### **TOWN OF MEDWAY**

## MODIFICATION ADULT RETIREMENT COMMUNITY PLANNED UNIT DEVELOPMENT (ARCPUD) SPECIAL PERMIT PLAN

Continuing Care Management, LLC The Willows at Medway and Whitney Place 259, 261, 261R and 263 Village Street

SUPPLEMENTAL WETLAND CROSSING AND SEWER LINING PACKAGE VILLAGE STREET, MEDWAY, MASSACHUSETTS 02053

SHEET NO.

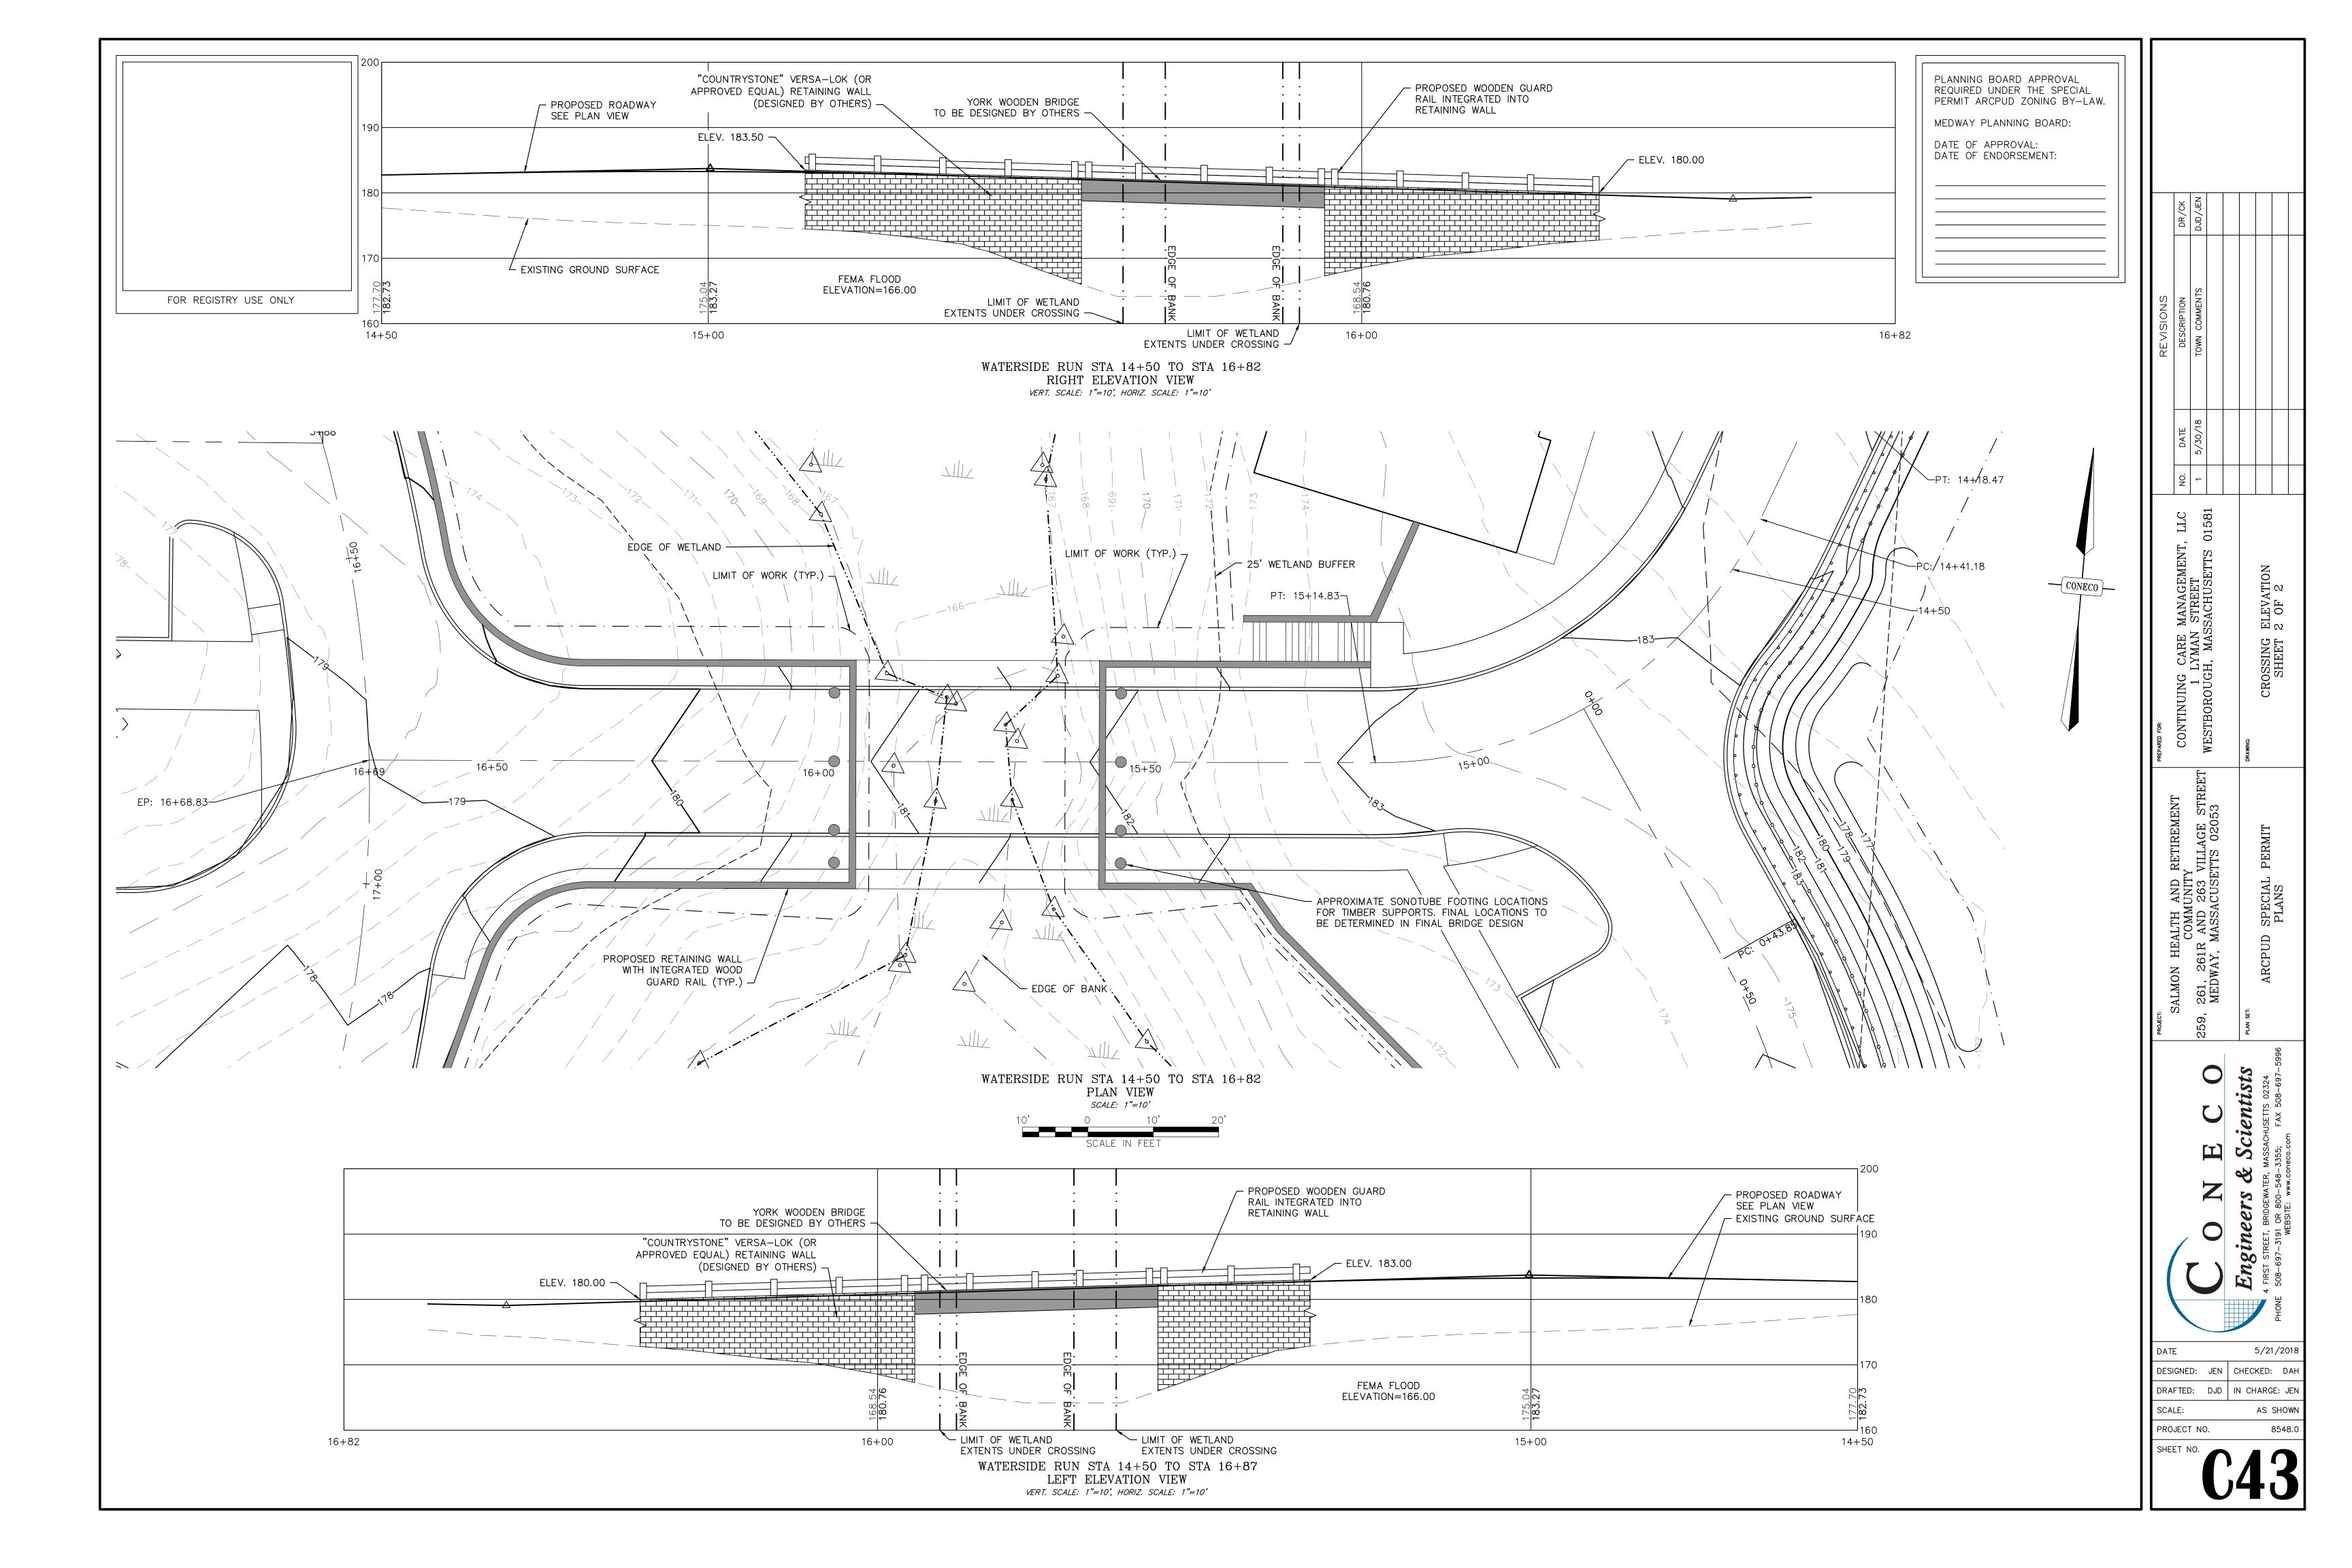
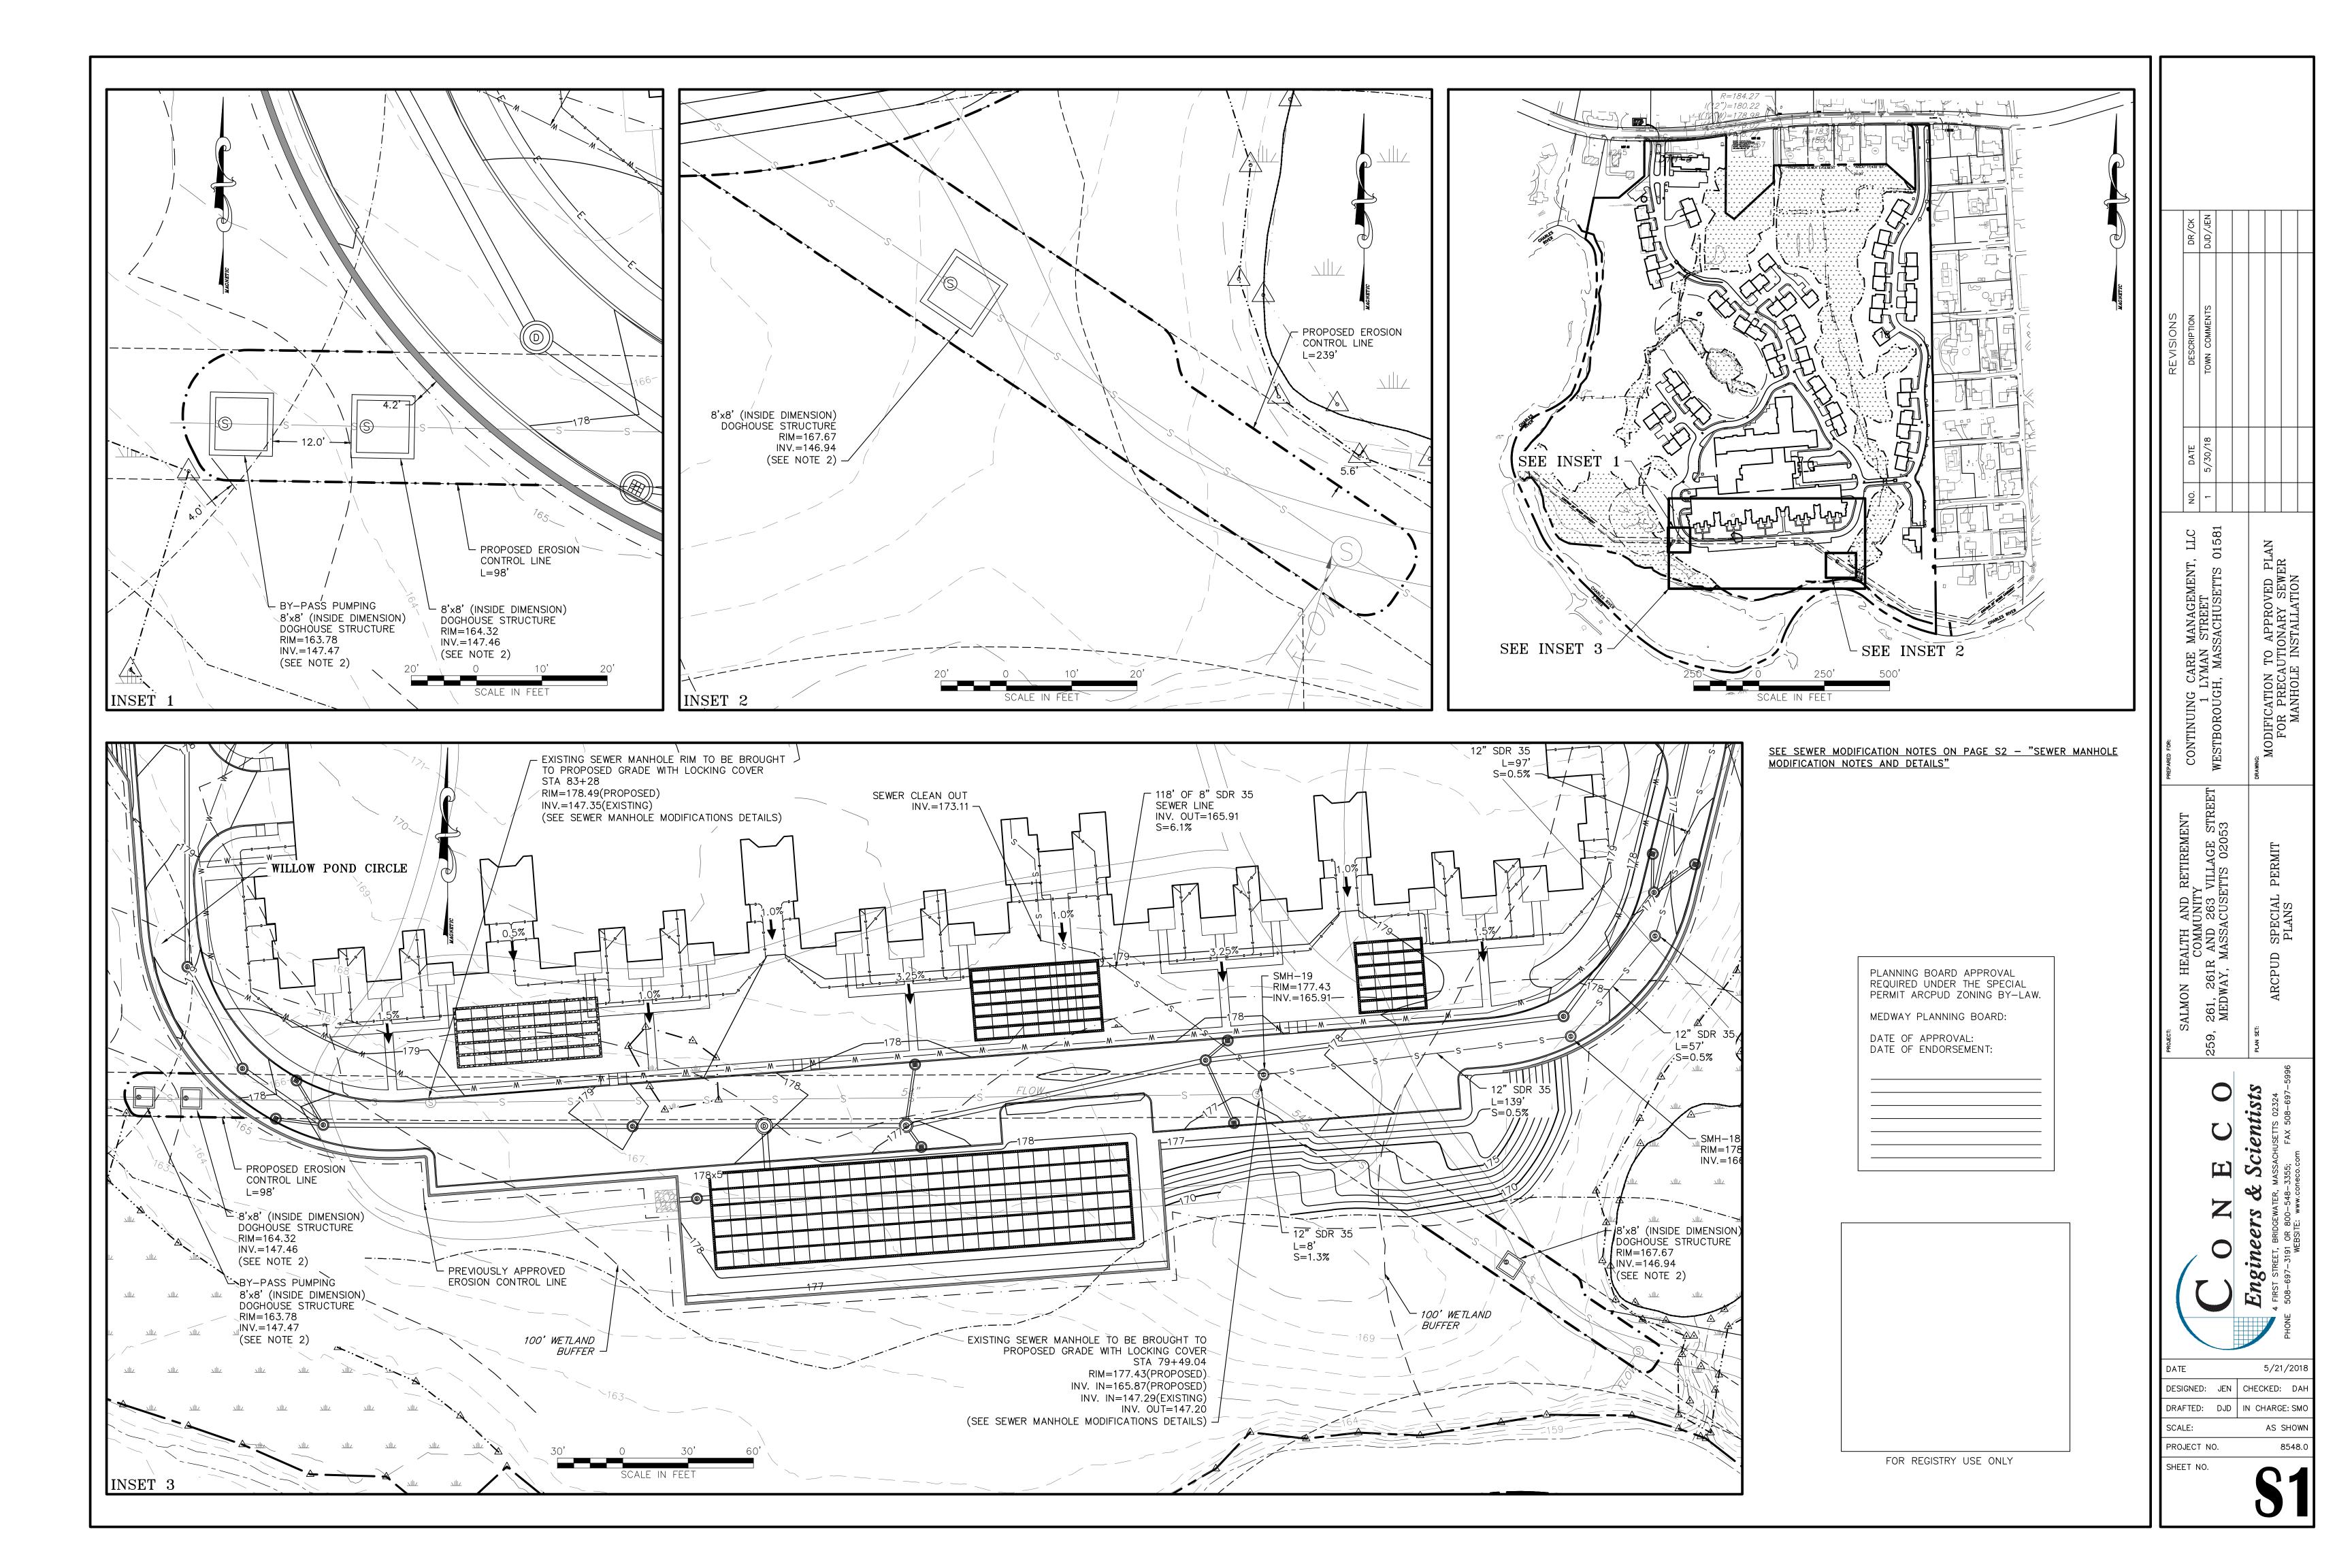
**DESCRIPTION OF PROPOSED MODIFICATION** – The proposed plan modifications were represented on the plan *Supplemental Wetland Crossing and Sewer Lining Package*, prepared by Coneco Engineers and Scientists of Bridgewater, MA, dated May 21, 2018 (Cover Sheet plus Sheets C1, C35, C36, C41, C42, C43, S1 & S2). The plan revisions reflect changes developed during the preparation of construction drawings and pertain to the following:

- Changing the structures for the two wetlands crossings from the previously approved precast concrete culvert crossings to wooden bridges. These bridges will be less intrusive on the wetlands because the abutments use driven piles. The wood alternative is a more attractive option and will enhance the overall aesthetic of the development. This bridge option should also be able to eliminate the shoring/sheeting associated with the previously approved culvert structures and bring the stream crossing design closer to the optimum design guidelines of the "Massachusetts River and Stream Crossing Standards."
- Adding three manholes to access the Charles River Pollution Control District (CRPCD) main sewer trunk line which crosses the Salmon property in order to access the pipe to make needed repairs, as may be required by the CRPCD.

- 1. THE PLANS CONTAINED IN THIS SET ARE INTENDED TO REPLACE SHEETS C35, C36, C41, C42, AND C43 OF THE PREVIOUSLY APPROVED "ARCPUD SPECIAL PERMIT PLANS" BY CONECO ENGINEERS AND SCIENTISTS, INC. LAST REVISED MAY 23, 2016. THESE SHEETS ARE BEING REPLACED PER THE MODIFICATION TO THE PREVIOUSLY APPROVED WETLAND CROSSING.
- ALL NOTES AND SPECIFICATIONS STATED IN THE "ARCPUD SPECIAL PERMIT PLANS" BY CONECO ENGINEERS AND SCIENTISTS, INC. LAST REVISED MAY 23, 2016 APPLY TO THIS SET.
- ALL WORK SHOWN IN THIS PLAN SET IS WITHIN THE PREVIOUSLY APPROVED LIMIT OF WORK. NO ADDITIONAL WETLAND OR BUFFER IMPACTS ARE PROPOSED IN THIS PLAN SET.
- 4. WETLAND CROSSINGS TO BE IN AESTHETIC STYLING OF POINTE WEST BRIDGE IN VERO BEACH, FLORIDA OR APPROVED EQUAL. (SEE YORK BRIDGE CONCEPTS, INC. IMAGE ON BOTTOM RIGHT OF THIS SHEET).

The plan was reviewed by Tetra Tech, the Town's Consulting Engineer. There were no issues with the proposed bridge changes as they do not increase disturbance compared to the previously approved crossings; the land disturbance is actually less overall. Upon review of the proposed modification, the Planning and Economic Development Board determined that the proposed changes will not be detrimental to the achievement of the planned senior living community as originally approved.
